Reference: Case No. PD-270-RBN, The Avenue at Denton Tap, a zoning change request from Commercial to a Planned Development to allow 29 multifamily units and 8,575 square feet of office/retail uses on 1.77 acres of property located at the northwest corner of Southwestern Boulevard and South Denton Tap Road.

STAFF REPORT

CASE NO. PD-270-RBN, The Avenue at Denton Tap

Site Plan

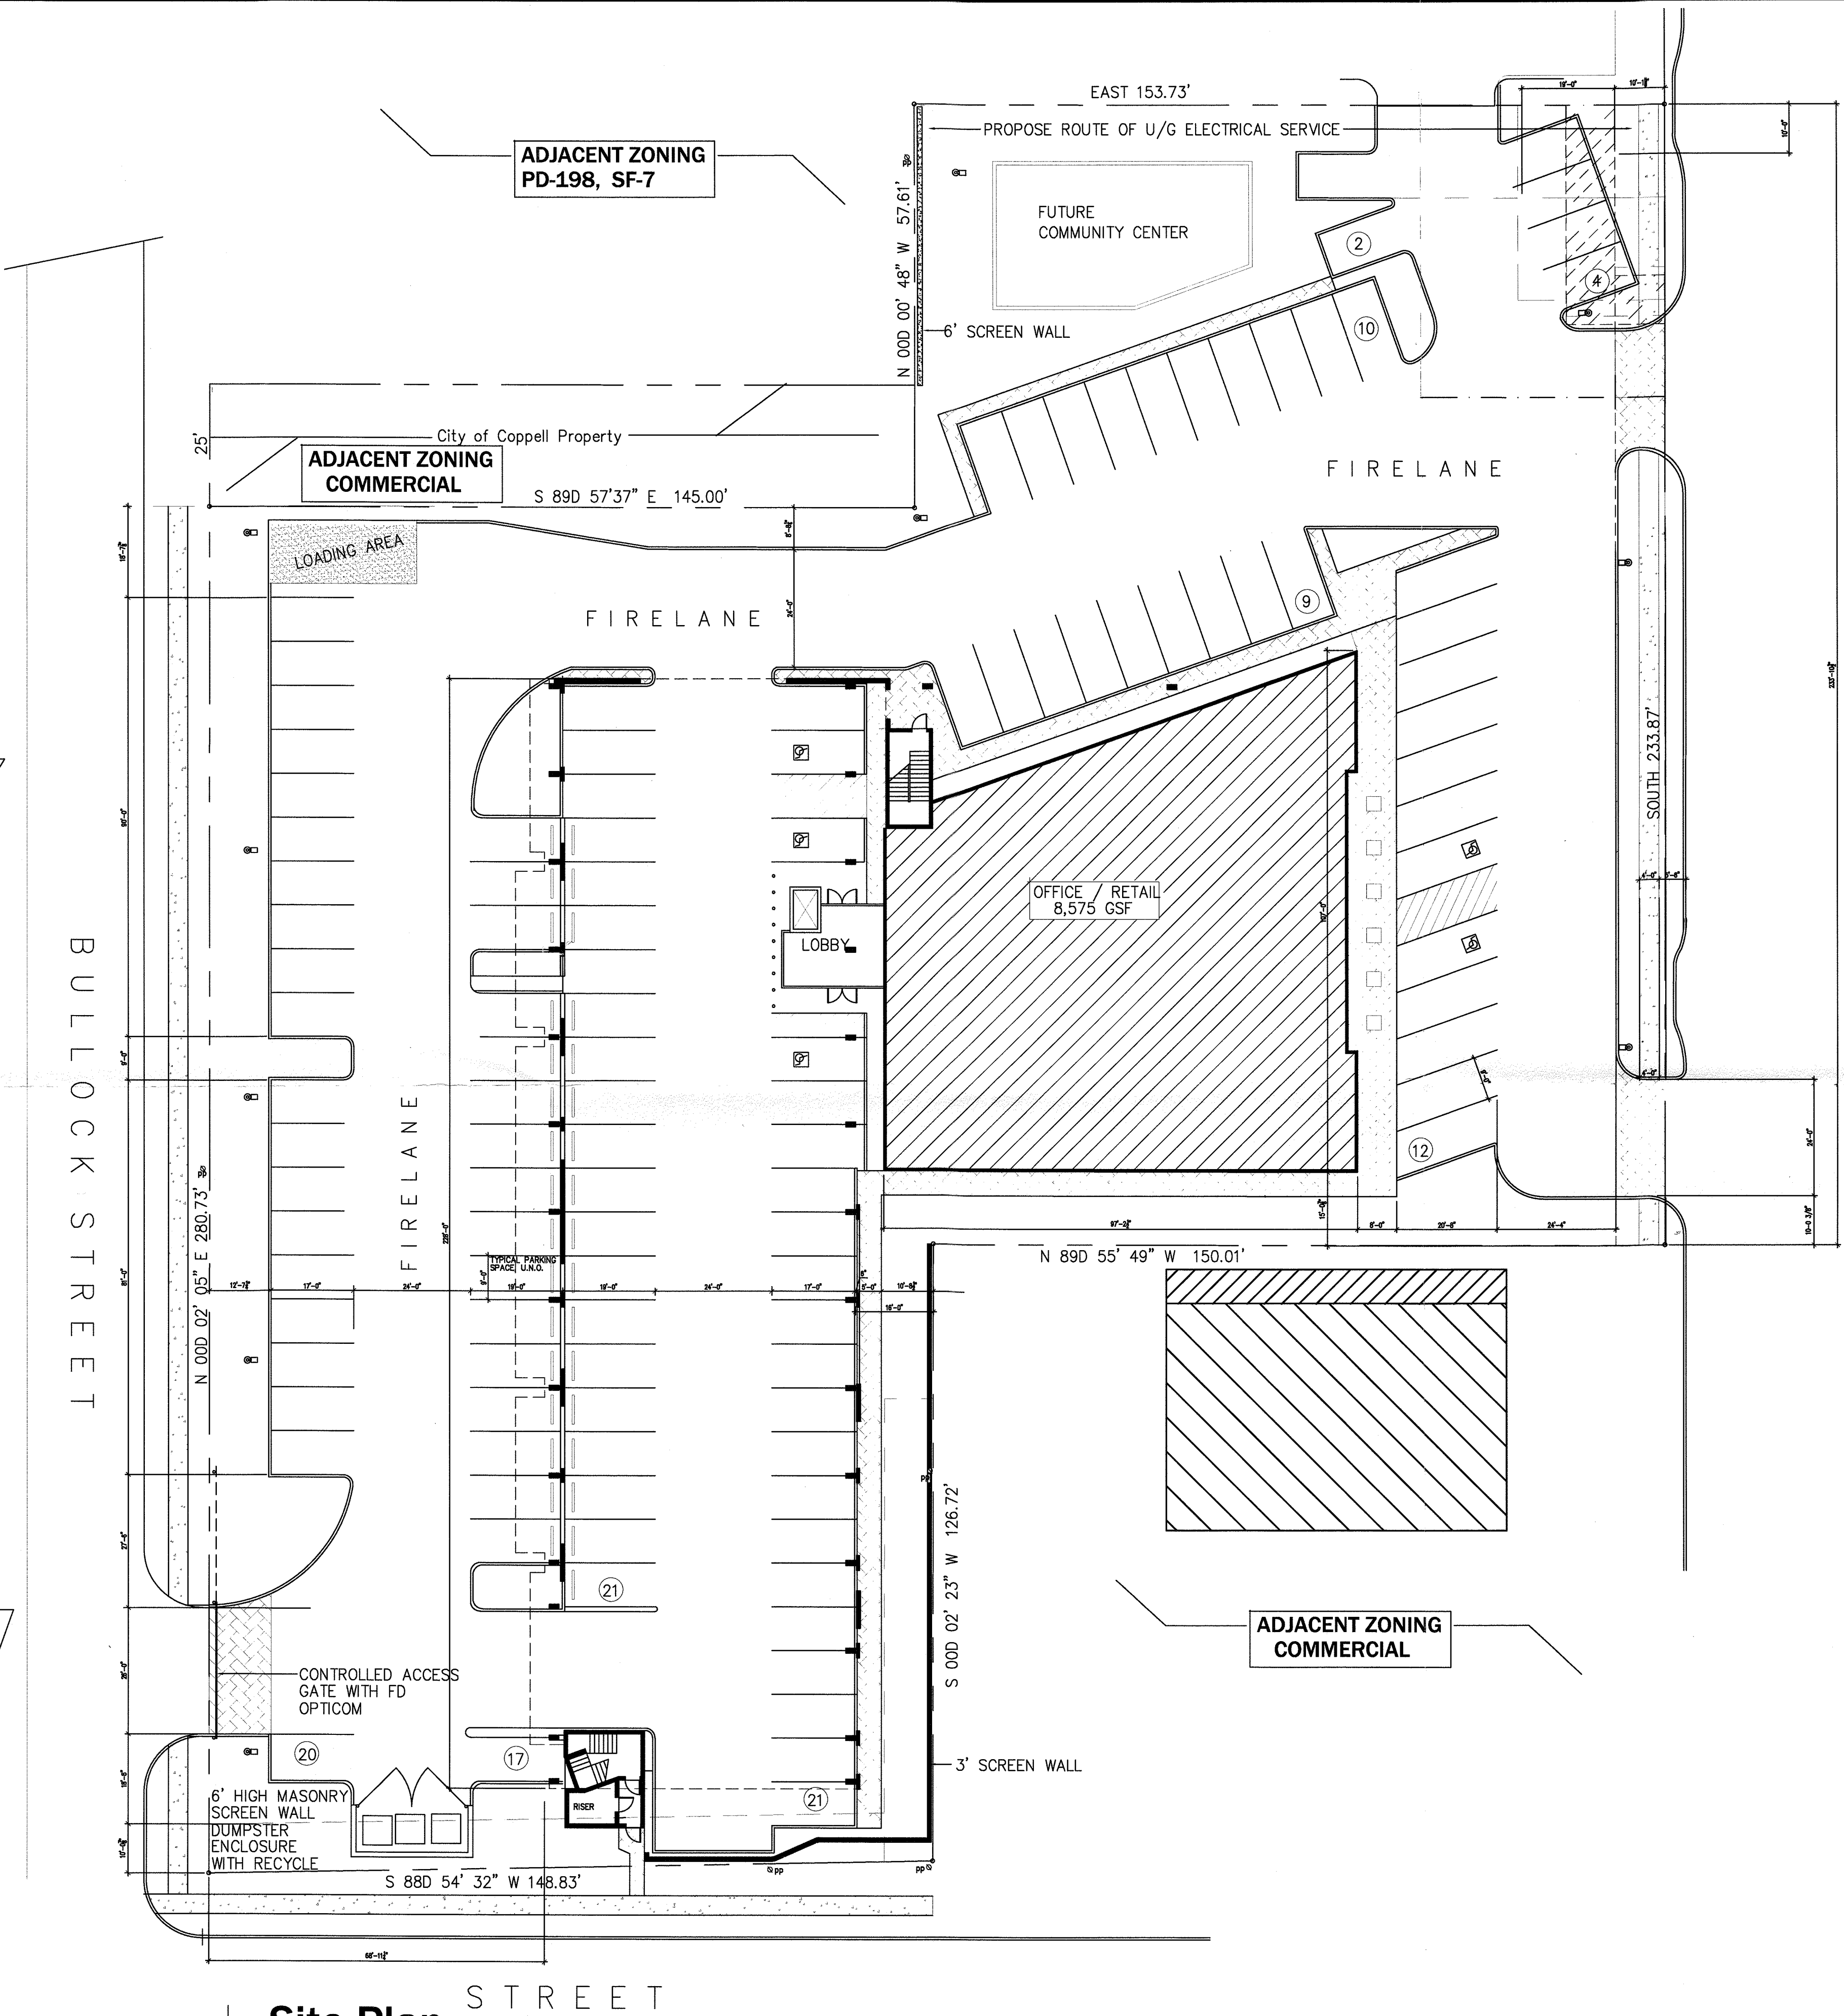
This building is proposed to be setback 63 feet from Denton Tap Road and 69 feet from Bullock Street. It is recommended that the 69-foot setback be supported to keep a buffer and transition from the residential neighborhood into the proposed higher intensity mixed use development.

A 36-foot setback is proposed along the northwest property line, which is adjacent to a 25-foot right-of-way providing a greater separation from the residential neighborhood. The main building is 63 feet from the Denton Tap Road right-of-way where the RBN District calls for a building to be no more than 15 feet from the lot line. Staff can support this deviation, as both a drive and parking are warranted for the office/retail use.

This proposal exceeds the 116 parking space requirement by providing 119 spaces. Both the *Comprehensive Plan* and the RBN District encourages structured (garage) parking. In this development 41 of the 119 spaces are contained within the structure. It is recommended that this parking area on the first floor be better screened with a three-foot masonry wall incorporated into each façade and this has

been listed as a condition of approval. Beyond the structured parking are 41 spaces in a parking lot. This area is proposed to be screened with a 12 foot wide landscaped area east of Bullock Street. The proposed off-street parking and drive (similar to a slip street recognized in the Comprehensive Plan). The proposed parking located on the Denton Tap Road side is angled with a one-way drive to provide an opportunity for streetscaping without actually having dangerous on-street parking on Denton Tap.

| 5. | A three-foot masonry wall shall be incorporated in the façades of the main building to better screen parking area contained within the building. |
| 14. | List all requested variances to the RBN District in the PD Conditions table. |
| 17. | Relocate the dumpster enclosure to the south end of the project. |

1 LANDSCAPE PLAN
SCALE 1"=20'

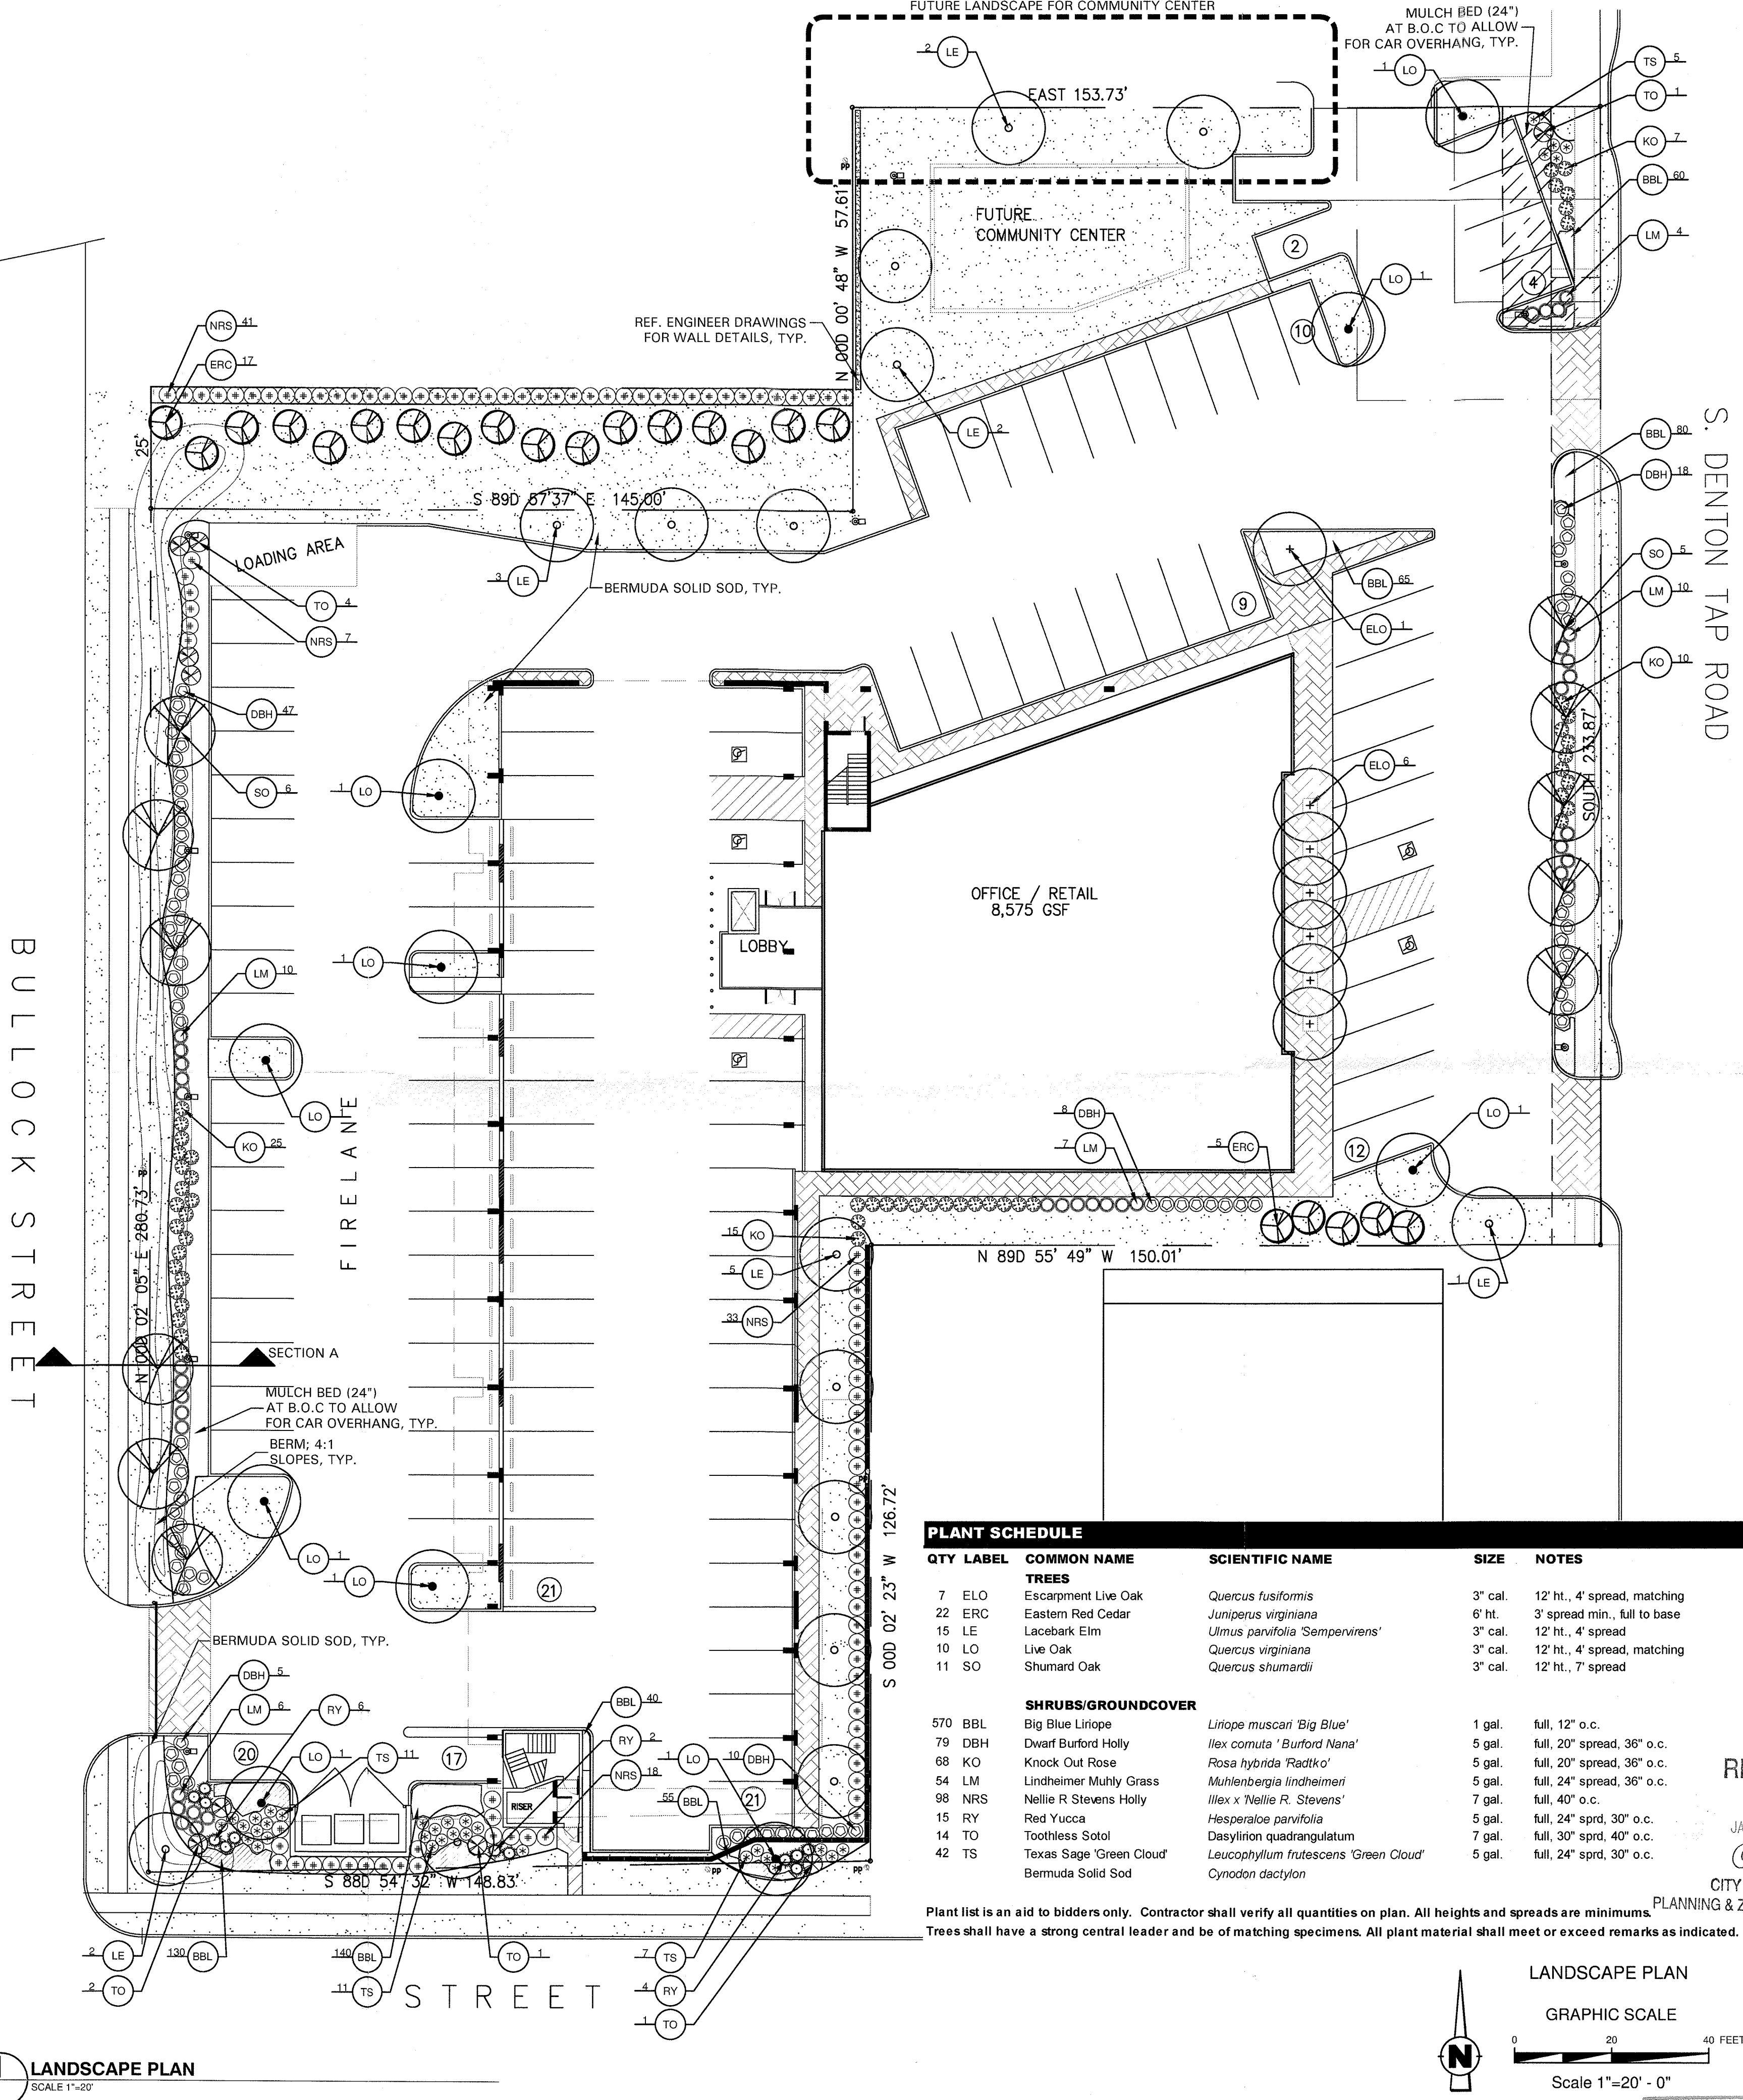
The landscape areas within a RBN District are different than the typical business zoning districts where under the RBN, a minimum 15% open space/common area is required. The proposal indicates that 17% has been provided. The streetscaping of the retail/office area is adequate where street trees are being provided. However, additional landscape islands are being recommended in the parking lot where there is no structure over the parking. Not more than 15 parking spaces are typically permitted without an island and one island is required at the end of each parking row; therefore, three islands are recommended. Also, the applicant has agreed to add an evergreen area of landscaping (containing Nellie R. Stevens and Eastern Red Cedars) to the 25 foot right-of-way strip located northwest of the property to better buffer/screen this proposal from the existing residential neighborhood.

| 8. | Include three 150-square-foot landscape islands with an overstory tree within the proposed surface parking area where not under the structure. No more than 15 spaces are typically permitted without an island and one island is required at the end of each parking row. |
| 12. | Label the 25-foot right-of-way northwest of the site as City of Coppell Property. Include Eastern Red Cedars and Nellie R. Stevens south of the existing fence. |
| 15. | Revise the Landscape Plan to include interim and future landscaping for the "Future Community Center" portion of the site. |
